WICTA

SERVICE BULLETIN NO. 54 Iss.

SUBJECT: Mandatory Inspection of Nose Leg Spring Characteristics.

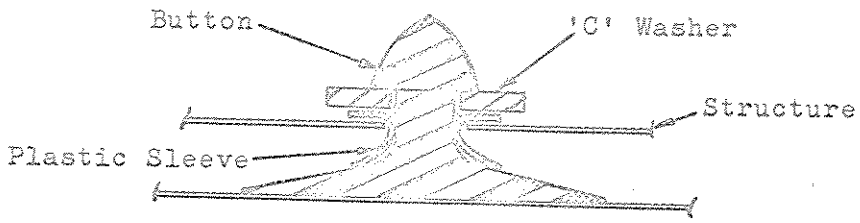
(g) Install C washers (Pt.No. 02-48023/1) making sure they pass between the end of the plastic sleeve and the head of the button. Rotate the washer when in position to flare out the ends of the sleeve as shown in the sketch.

(d) Cut off a .30" length of softened tube, ensuring the ends are square and push over tank button. Allow bottom of sleeve to flare out over base of button using a blunt instrument to remove any fold unders and to provide a smooth skirt around the neck of the button.

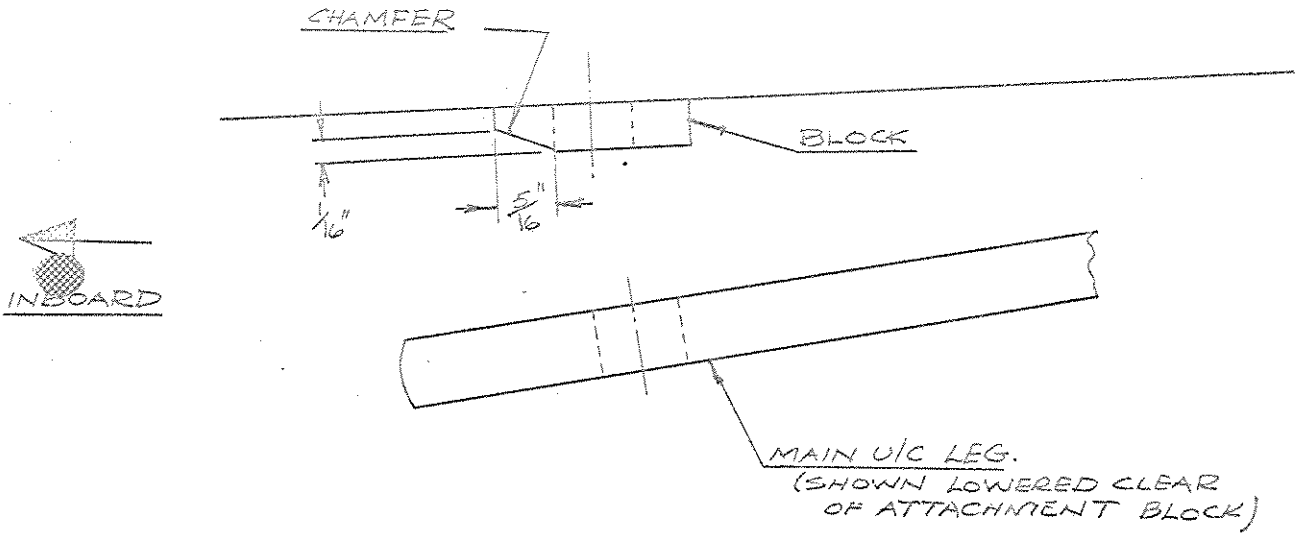
DETAILS: (a) BOLT REPLACEMENT

Remove screws and drop undercarriage fairing.
Trestle wings with main landing gear clear of ground.
Remove inner main leg attachment bolts and loosen clamp plates.
With leg clear of inner attachment block, chamfer inboard edge of block as shown:

Use a piece of scrap sheet metal against wing under skin to prevent damage when filing chamfer.

REWORK DETAILS

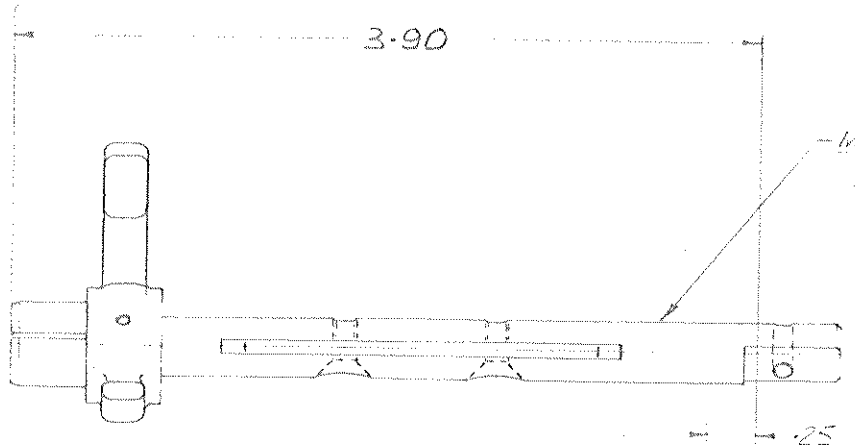
Throttle shaft part No. 03-43308/1 may be purchased complete through Victa Service Department or alternatively may be re-worked from shaft assembly, Marvel Schebler Part No. A13-949 in accordance with page 3. of this service bulletin.

PART NO 03-43308/1 IS MADE BY
REWORKING MARVEL SCHEBLER
PART NO 413-949 AS SHOWN

DRILL THRU 1/16" DIA
